Amendments to the Drawings:

REMARKS

ANNOTATED SHEET

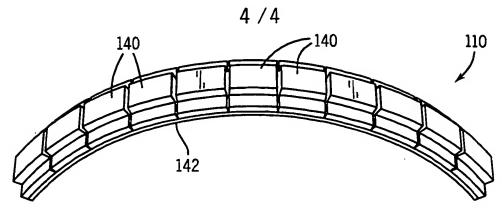
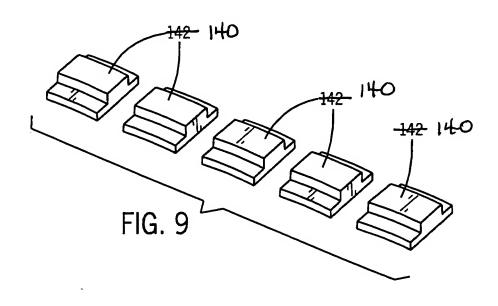
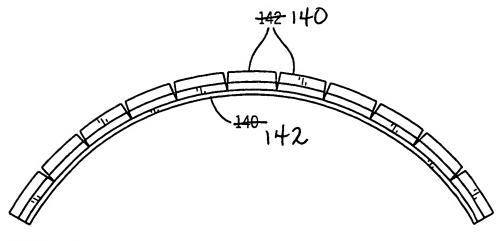
The Office has objected to the drawings under 37 C.F.R. § 1.121(d) it appears "that

references "140" and "142" are reversed in the drawings." Applicant has made the appropriate

correction to the drawings. In view of the foregoing amendments and remarks, the Office is
